Access Compliance Report

Public Rights-of-Way

(Curb Ramps)

Intersection ID: N/A	Main Street: PROVIDENCE_RD	Cross Street: BERKELEY_GREENE_DR	Location: SW
ADA ID: 81D351477271	Ramp Type: Perp	Initial Pass/Fail: Fail	Overall Compliance: No
Severity Score: 72.5			
Codes/Mitigation Info/Possible Solution		Field Measurements/Component Compliance

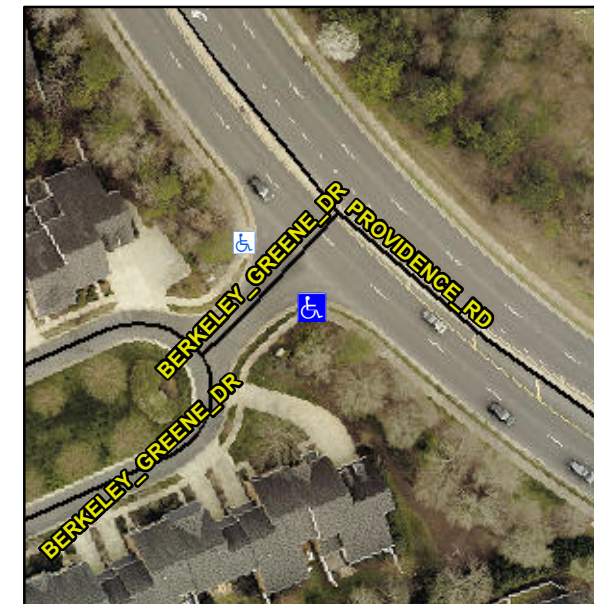
Not Found, R304.5.1, R304.2.2, R304.5.3

Compliance	Description	Data	Compliance	Description	Data
N/A	Ramp Length (in)	81.5	No	Ramp Slope (%)	13.1
No	Ramp Width (in)	25.0	No	Ramp XSlope (%)	5.6
N/A	Flare Type LT	N/A	N/A	Flare Type RT	N/A
N/A	Flare Slope LT (%)	N/A	N/A	Flare Slope RT (%)	N/A
N/A	Flare Traversable LT?	N/A	N/A	Flare Traversable RT?	N/A
N/A	Landing Length (in)	N/A	N/A	DWS Provided?	N/A
N/A	Landing Width (in)	N/A	N/A	DWS Contrast?	N/A
N/A	Landing Slope (%)	N/A	N/A	DWS Length (in)	N/A
N/A	Landing X Slope (%)	N/A	N/A	DWS Full Width?	N/A
N/A	Landing Curb? (Y/N)	N/A	N/A	DWS Offset (in)	N/A
N/A	Shared Landing?	N/A			
N/A	Gutter Ponding?	N/A	N/A	Gutter Slope (%)	N/A
N/A	Gutter Lip Ht (in)	N/A	N/A	Gutter X Slope (%)	N/A
N/A	Painted X Walk1?	No	N/A	Painted X Walk2?	N/A
	X Walk 1 Direction	To NW		X Walk 2 Direction	N/A
N/A	X Walk 1 Width (in)	N/A	N/A	X Walk 2 Width (in)	N/A
	X Walk 1 Slope (%)	3.2		X Walk 2 Slope (%)	N/A
	X Walk 1 X Slope (%)	4.5		X Walk 2 X Slope (%)	N/A

Remove & Replace Entire Ramp.
